CTL DECISION SHEET

Standard(s) (incl. year)	Subclause(s)	No.	Year
IEC 60335-1(2010) + am1 (2013)	8.1.4	2013	2021
Category			
HOUS			
Subject	Keywords	Developed by	To be approved
PTC Enclosure heater in Class II construction	- Insulation coordination - Reinforced insulation, - Protective impedance	ETF 1	2022 CTL Plenary Meeting

Figure 1: Block diagram of measuring circuitry

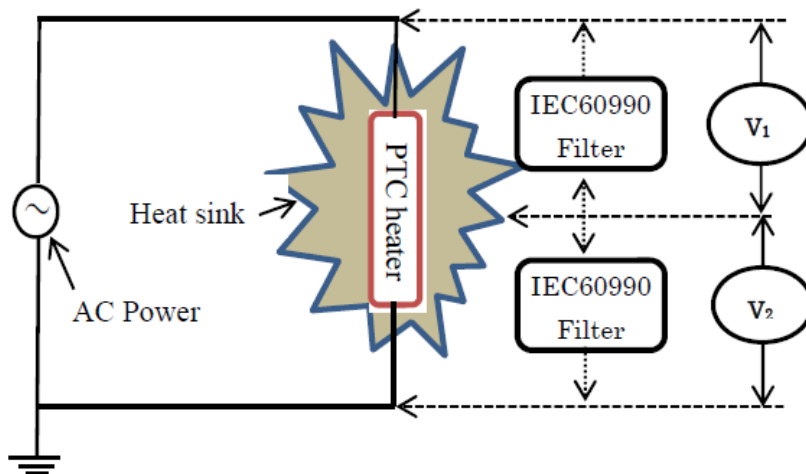
A PTC enclosure heater is protected against electrical shock by class II construction. The heating element is insulated by three layers of Kapton foil from the heat sink in compliance with sub clause 29.3.2.

The relevant tests of sub clauses 8, 13, 16 and 29 were passed with positive results.

Are the requirements of subclause 8.1.4 for protective impedance applicable for this design?

The standard can be interpreted in a way that the part of the heat sink shall comply with the requirement of protective impedance specified in subclause 8.1.4 if the voltage of the heat sink is greater than 42.4 V, which is measured without the filters specified in IEC 60990 as shown in the following table.

Instruments used	V ₁ (V)		V ₂ (V)	
	Filter disconnected	Filter connected	Filter disconnected	Filter connected
Digital multimeter A	82.03	0.0346	91.72	0.0344
Digital multimeter B	18.73	0.0392	20.56	0.0383

The requirements of subclause 8.1.4 for protective impedance are not applicable because there are no components (protective impedance specified in 3.3.6) connected between live parts and the heat sink.

The requirement of the protective impedance shall not apply due to the following reasons:

1. There is no protective impedance used in the part in question but a floating capacitance therefore

the data measured without filter will vary depend of the impedance of measuring instruments.
2. Compliance with the first dashed item (42.4 V) of 8.1.4 is achieved with the filter specified in IEC 60990 referred in NOTE 1 of 8.1.4.
